CLASS II MODIFICATION 2019 - SUPPLEMENT
10/28/2019

Site Plan Supplement
Atlantic Crossing
Delray Beach
Florida

Drawing No.
SP-2B

Drawing No.
SP-3A

CLASS II MODIFICATION 2019 - SUPPLEMENT
10/28/2019

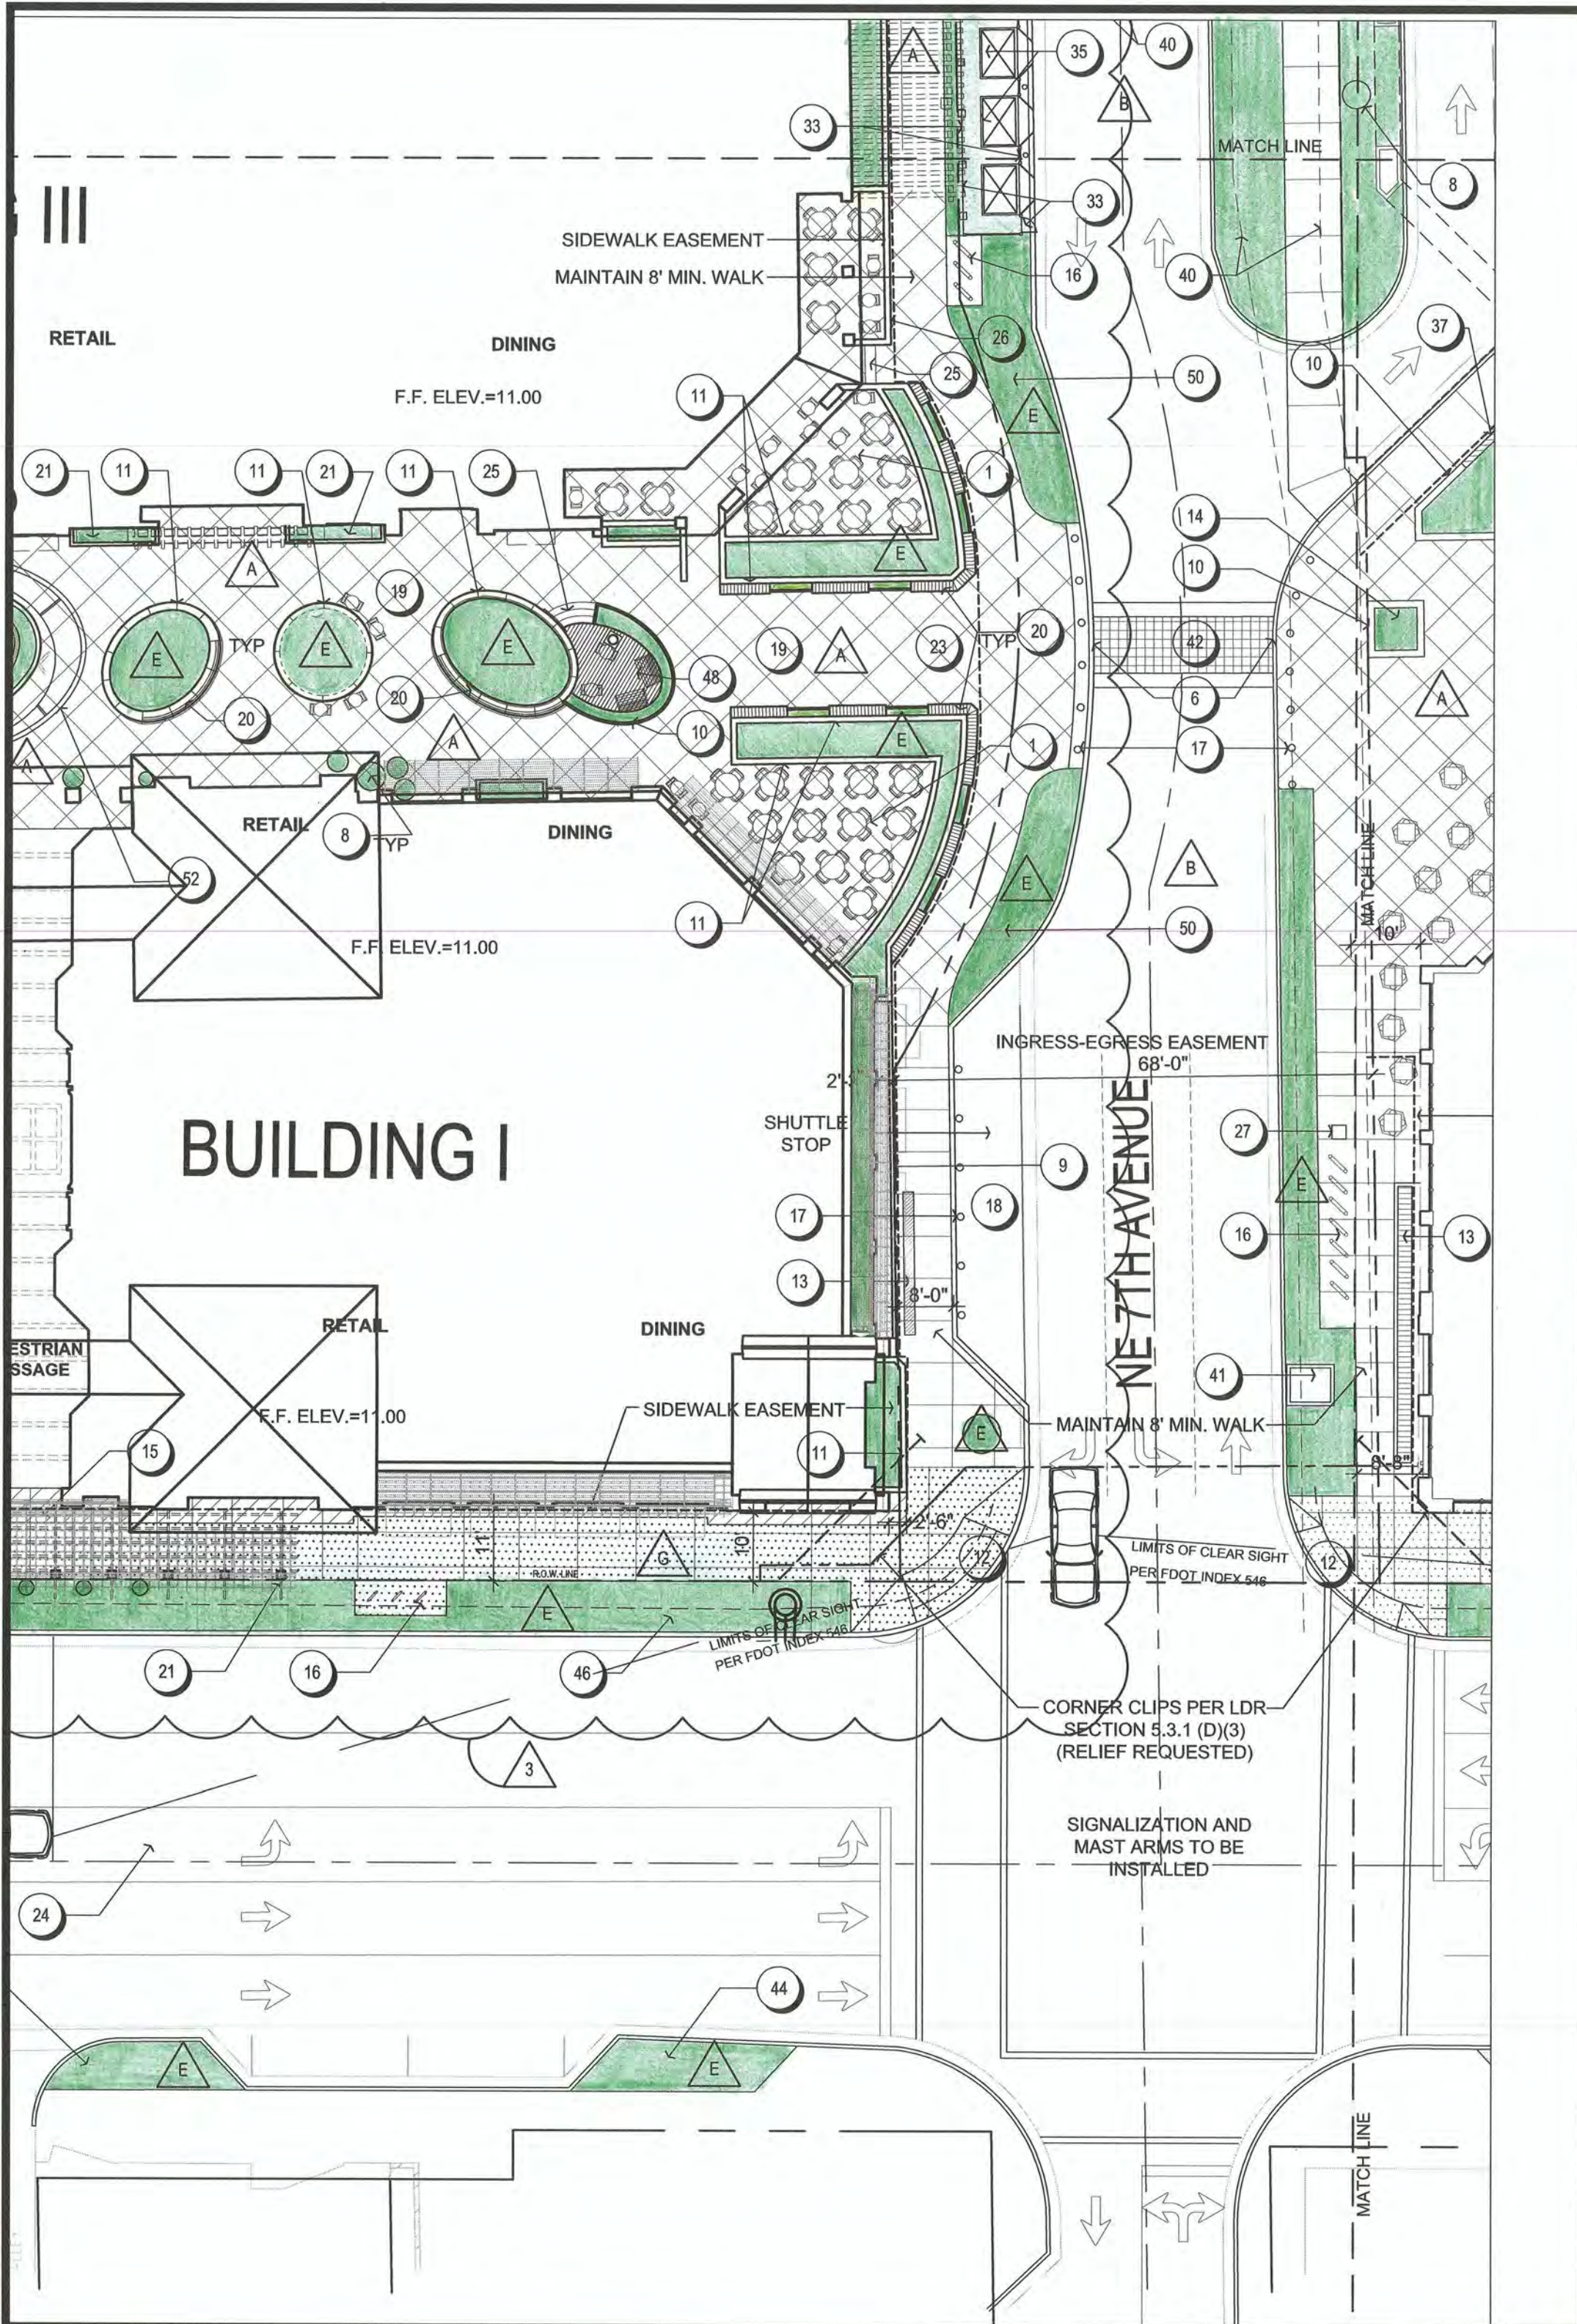
SUMMARY OF MODIFICATIONS

- 1. PLANTERS RE-DESIGNED TO ENABLE BETTER PEDESTRIAN FLOW TO ENABLE RETAIL TO SUCCEED.
- 2. AQUARIUM REPLACED BY ECHELMAN SCULPTURE.
- 3. RESTAURANT SEATING TERRACES BETTER DEFINED WITH PLANTER WALLS.
- 4. STAGE ADDED FOR SMALL MUSICAL PERFORMANCES.
- 5. INCREASED GREEN SPACE.
- 6. PLANTER BENCHES PROVIDE VIEWING FOR ECHELMAN SCULPTURE.

SITE PLAN

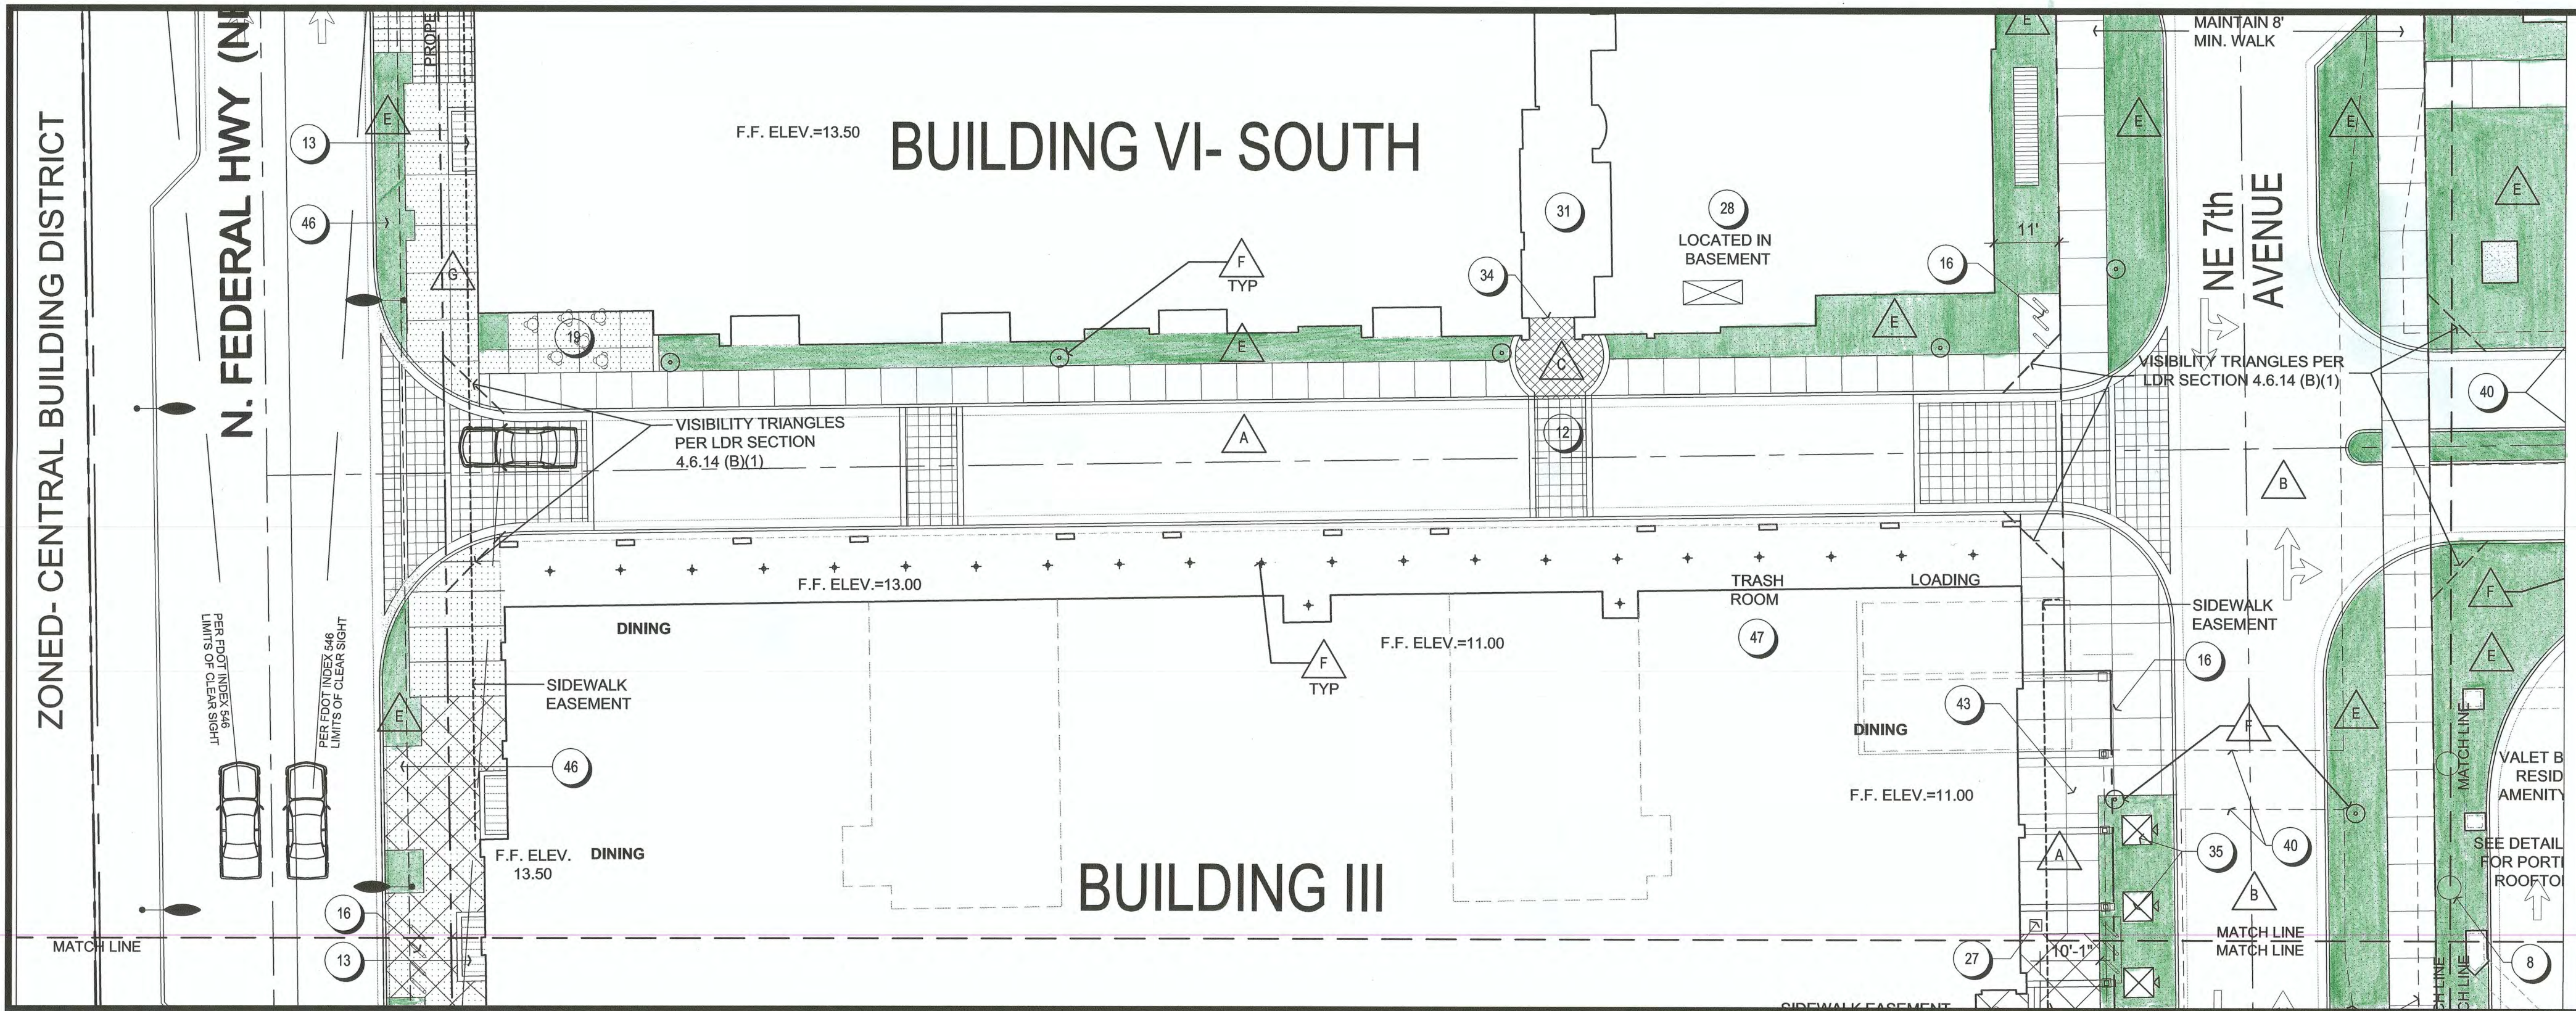
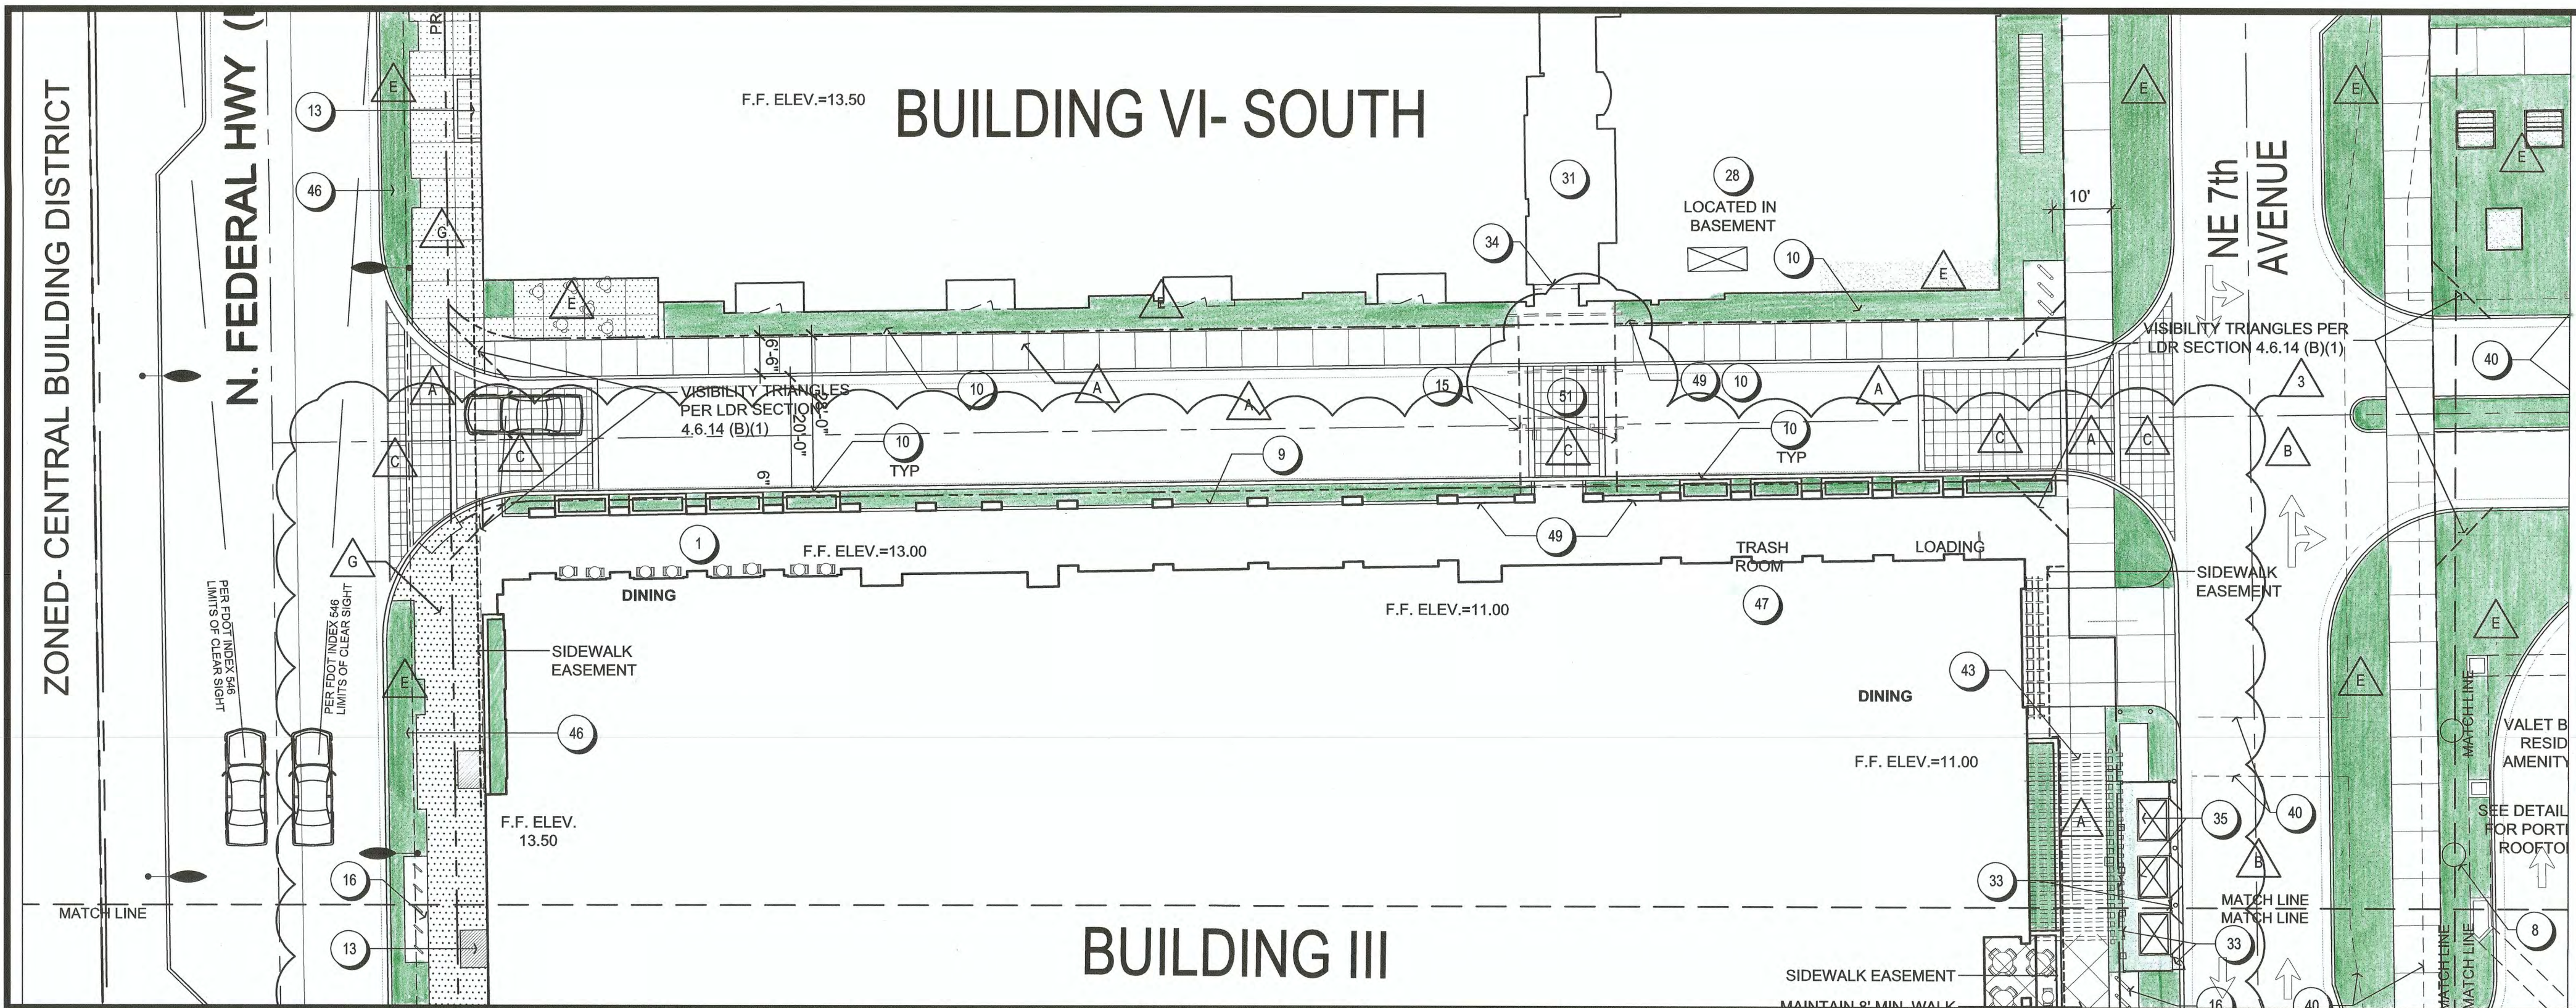
SUMMARY OF MODIFICATIONS

1. GREEN SPACE INCREASED.
2. PLANTERS PROVIDE ADEQUATE SOIL FOR SHRUBS AND SMALL PALMS.
3. OVERHEAD TRELLIS DELINEATES PEDESTRIAN CROSSING TO ENHANCE SAFETY.
4. SECONDARY MID-BLOCK PEDESTRIAN CROSSING ELIMINATED.
